ADDENDUM No. 1
Central Avenue Stormwater Improvements
CITY OF LAKE STATION
PROJECT NUMBER: 2022.00047

OCTOBER 14, 2025

CITY OF LAKE STATION
1969 CENTRAL AVE.
LAKE STATION, IN
46405

MILLING AND RESURFACING DETAIL
NOT TO SCALE

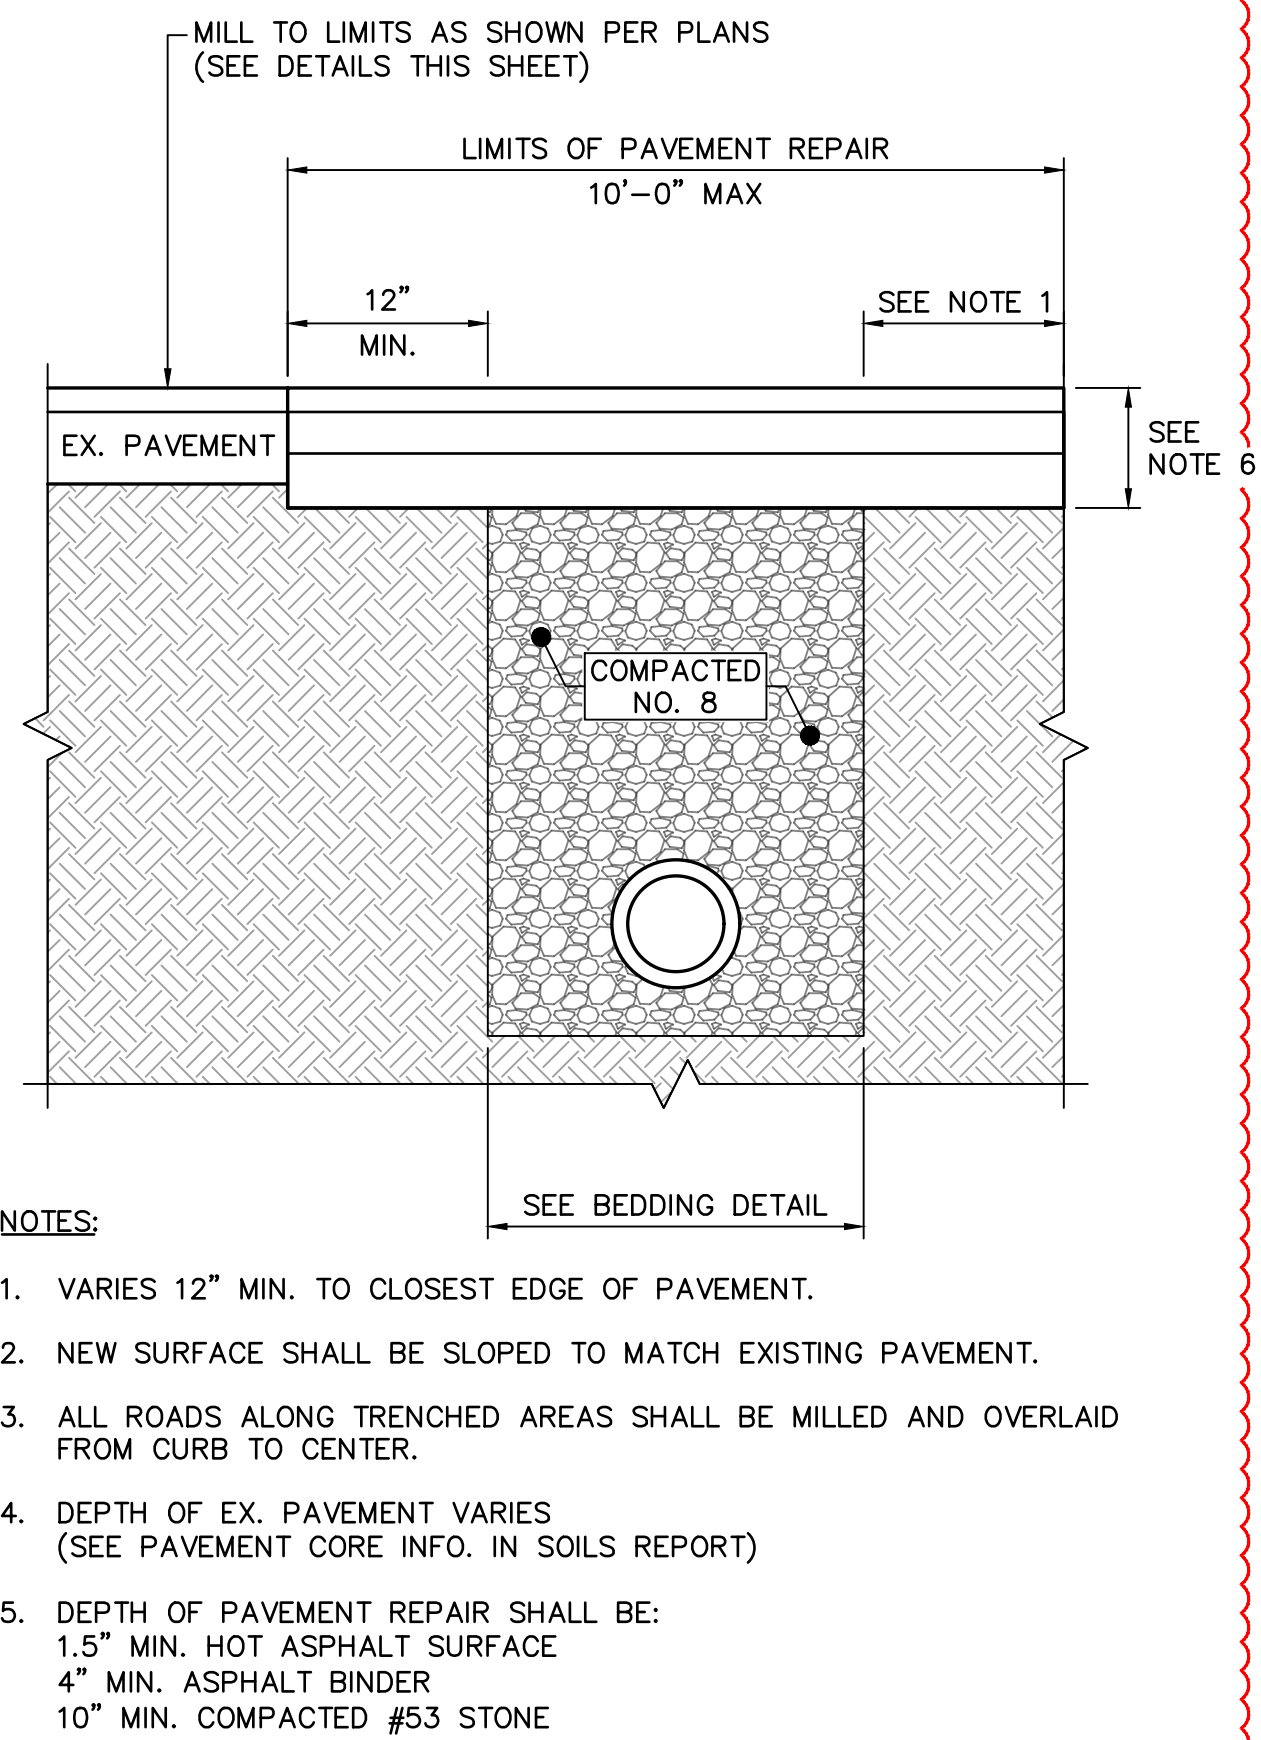
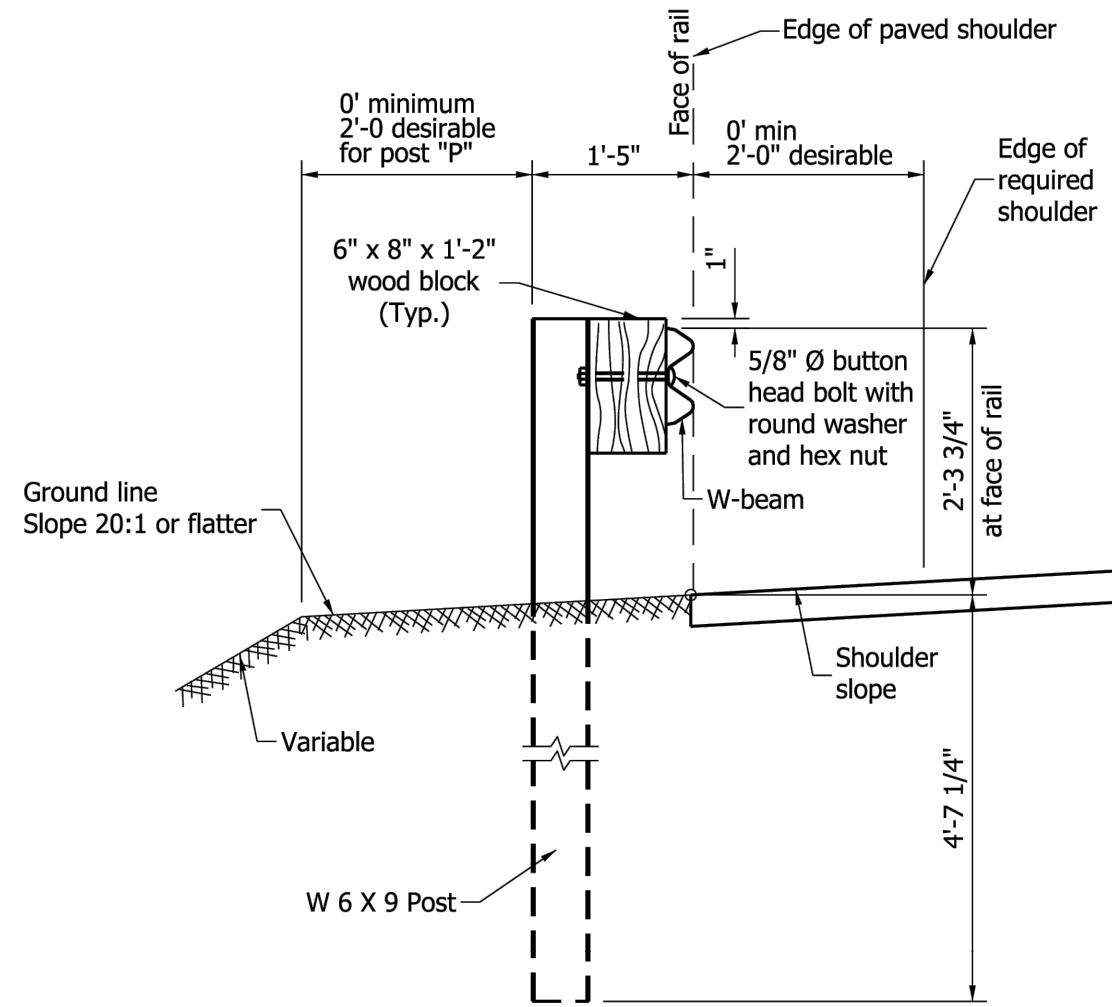
7. Replace sheets C-229 thru C-233 with revised sheets noting the additional information on compacted aggregate and the new milling and resurfacing detail.
